971 Richmond Road, Marsden Park

ISSUE E - AMENDMENTS - 15.07.21

DEVELOPMENT APPLICATION

Proposed Mixed Use Development

1 BLOCK 1-2 - BASEMENT LEVEL 2 1:400 @ A3

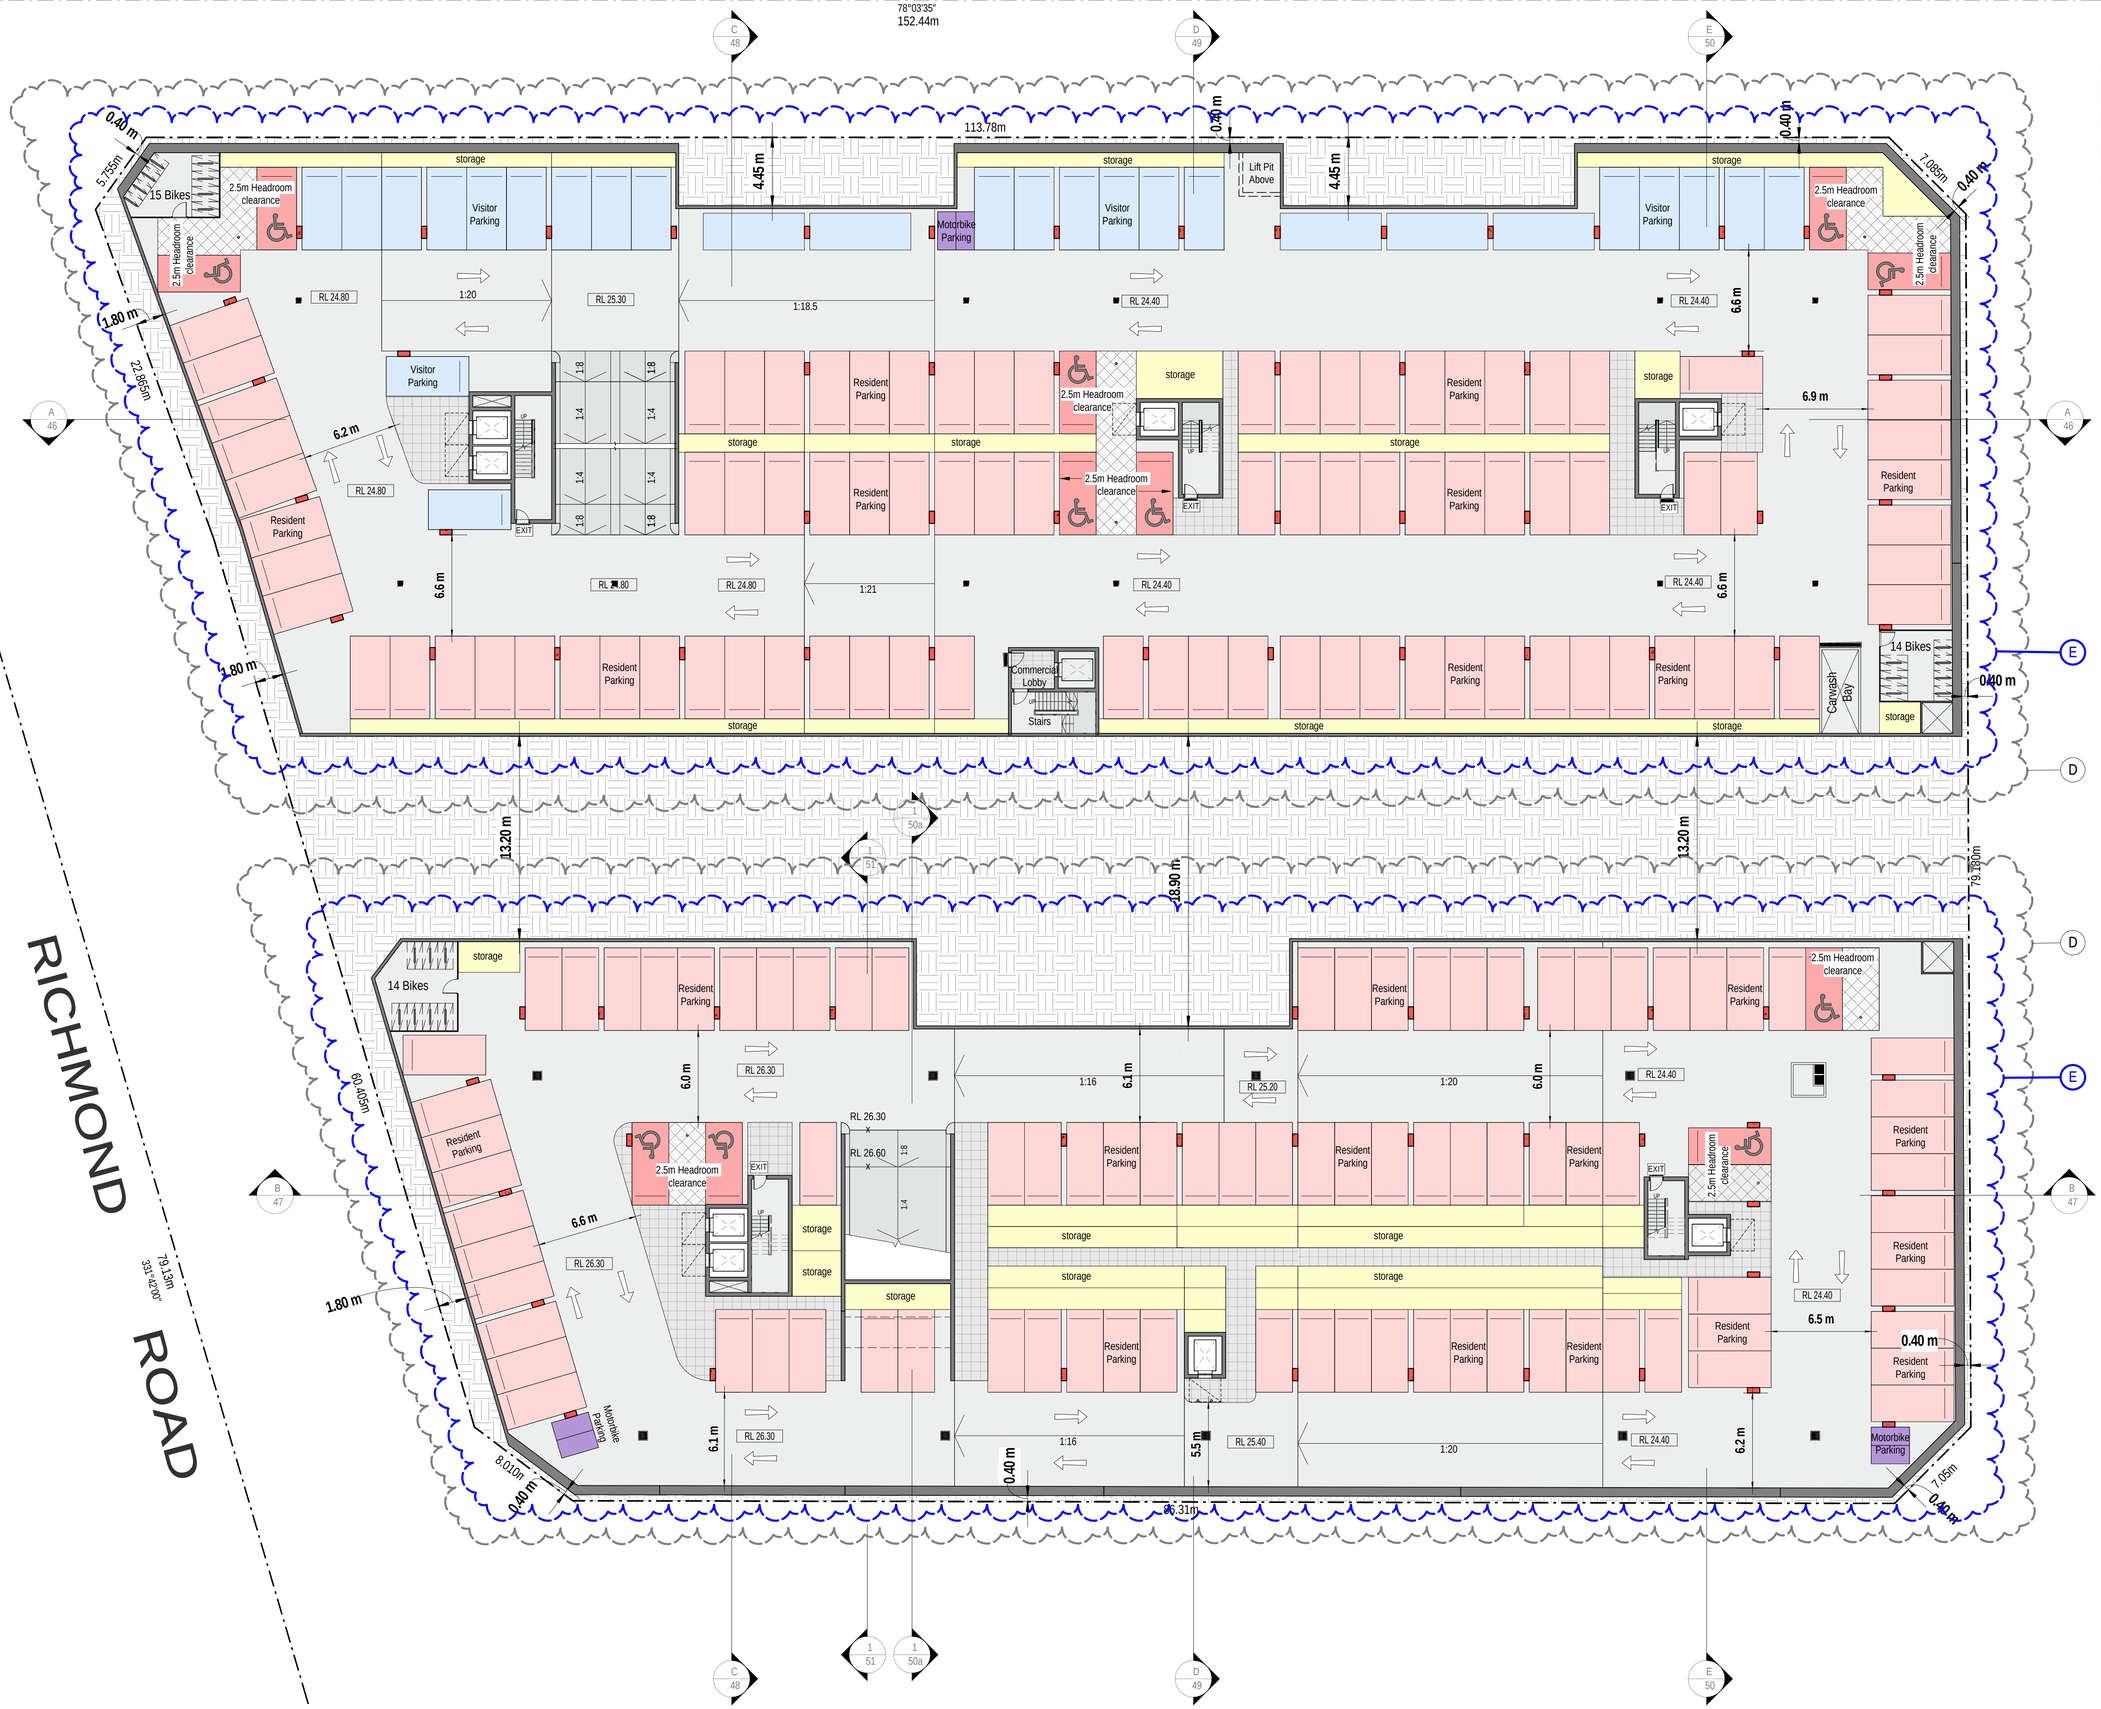
1. RLs amended to accommodate revised Civil drawing levels at Ground Floor.
2. Ramping within Driveways amended.
3. Stormwater pits added.

Title
Roof Plan

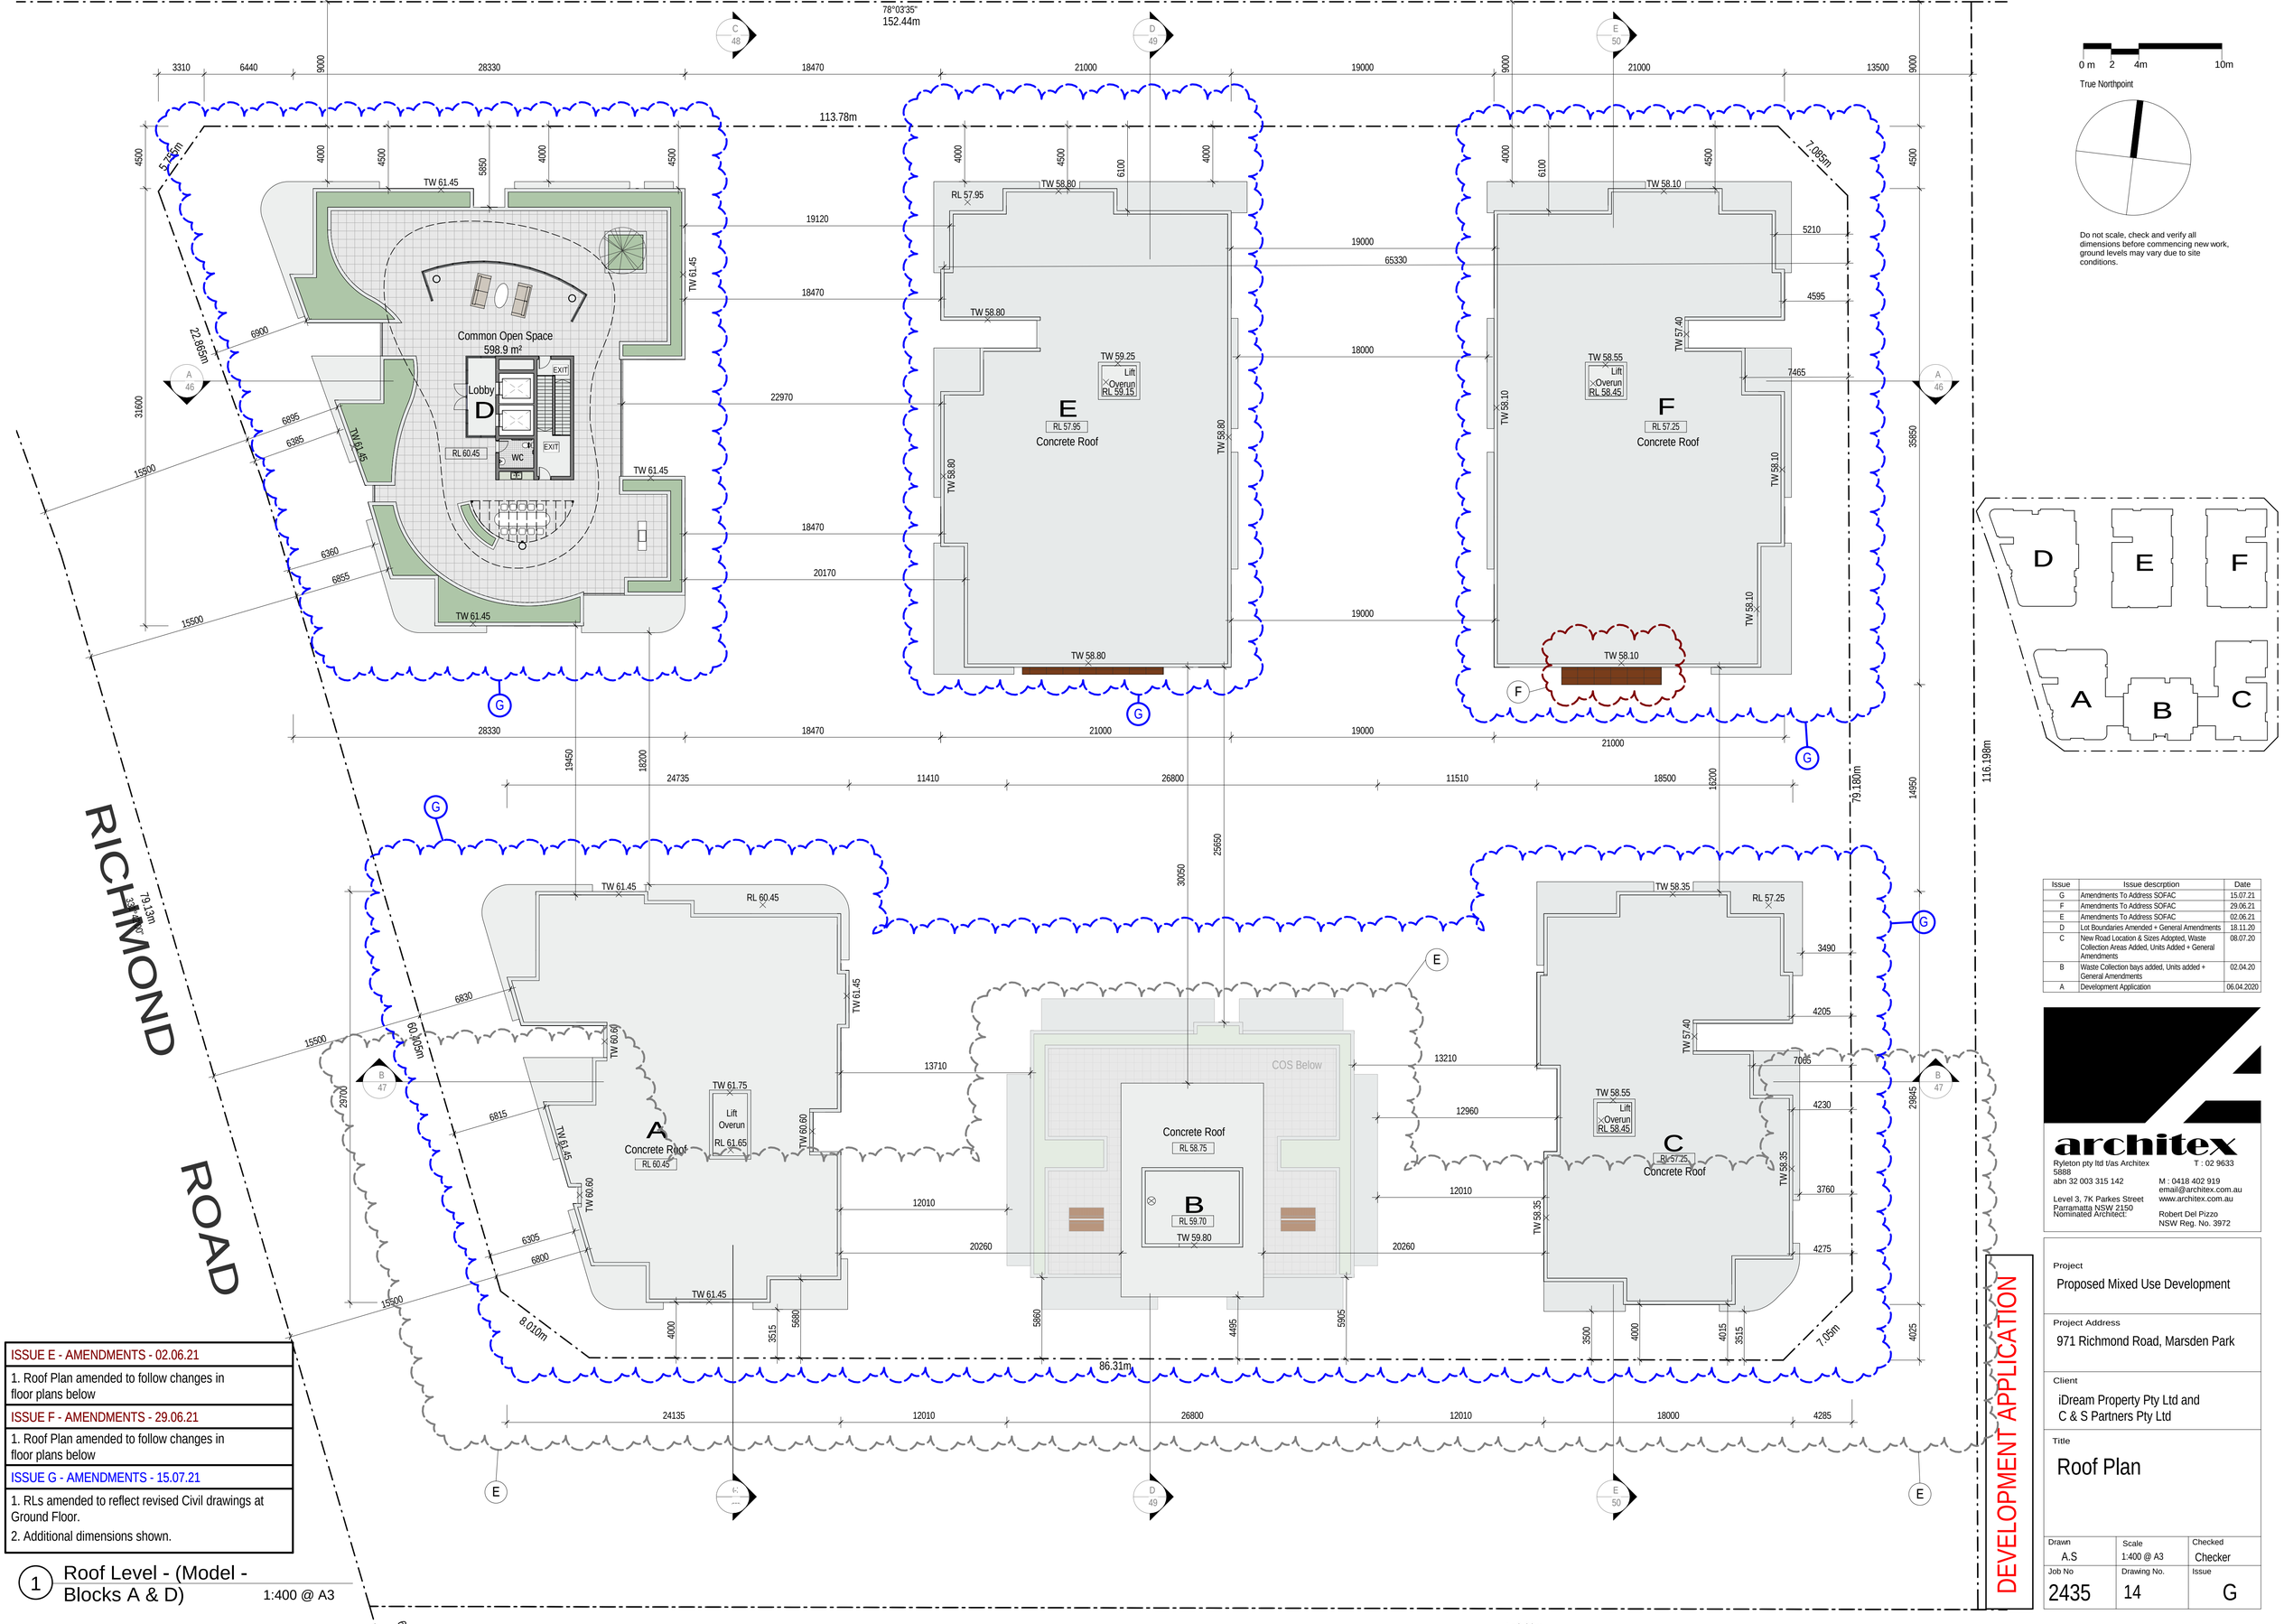
1. Roof Plan amended to follow changes in floor plans below

1. RLs amended to reflect revised Civil drawings at Ground Floor.
2. Additional dimensions shown.

1 Level 02 - Block A

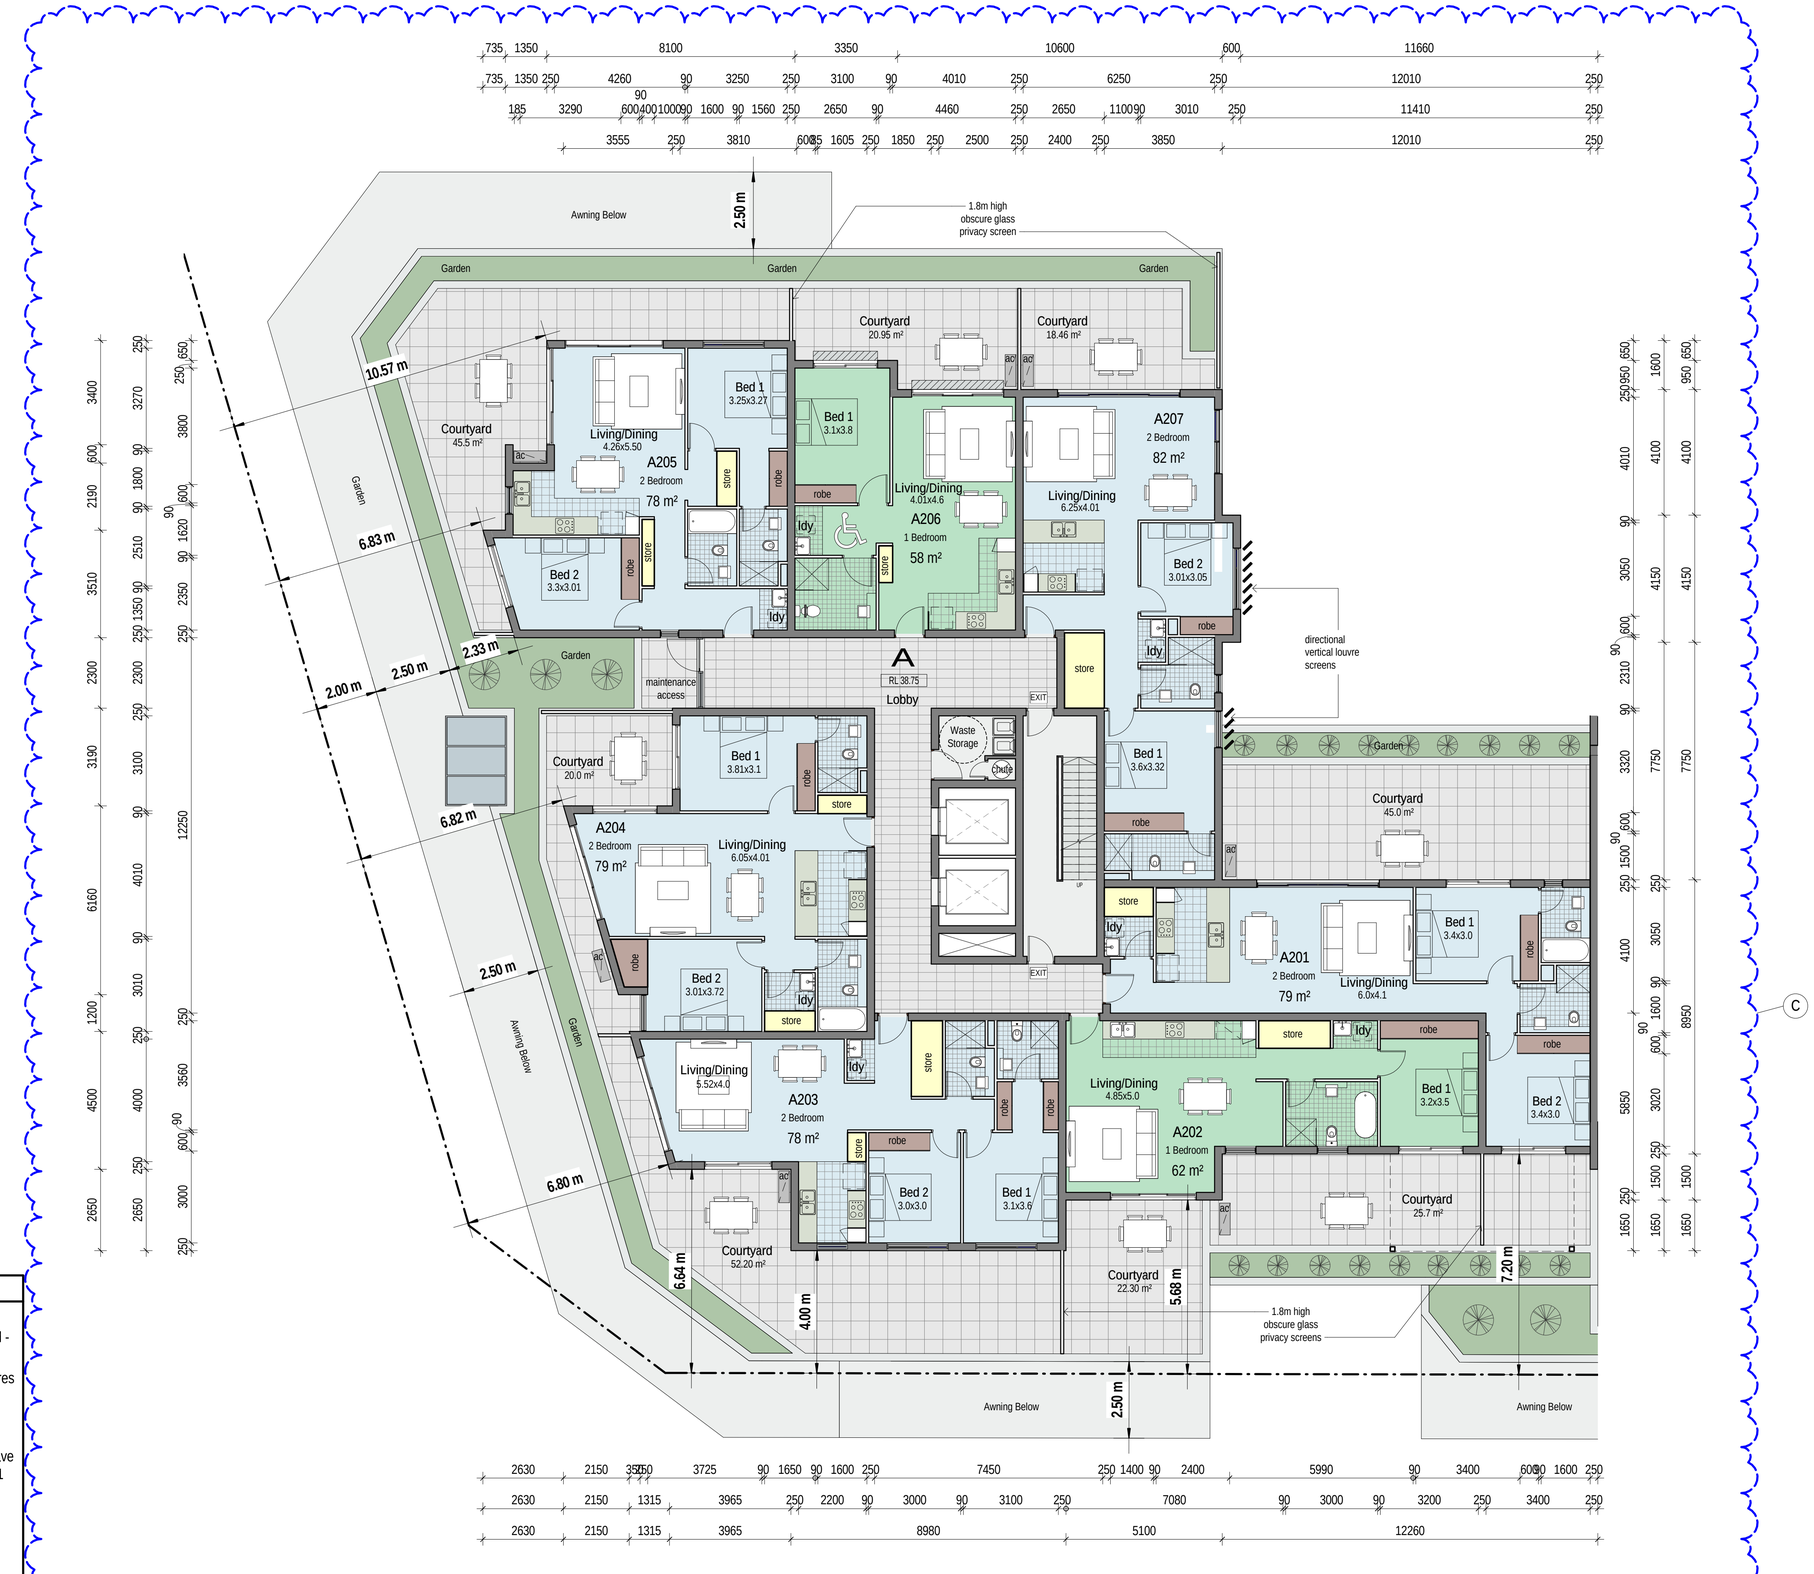
1. Lot 1 boundaries amended
2. Building below Setback 20m from Richmond Road - courtyards amended
3. Setbacks to Southern boundary adjusted to 4 metres minimum
4. Bridging elements between Blocks A and B, and Blocks B and C increased in width.
5. Block A – Units A201 (3 bed) and A202 (2 bed) have been reconfigured to create three units, namely A201 (2 Bed), A202 (1 bed) and A203.
6. Privacy Screens Added & noted
7. RLs amended to reflect revised Civil drawings at Ground Floor.
8. Additional dimensions shown.
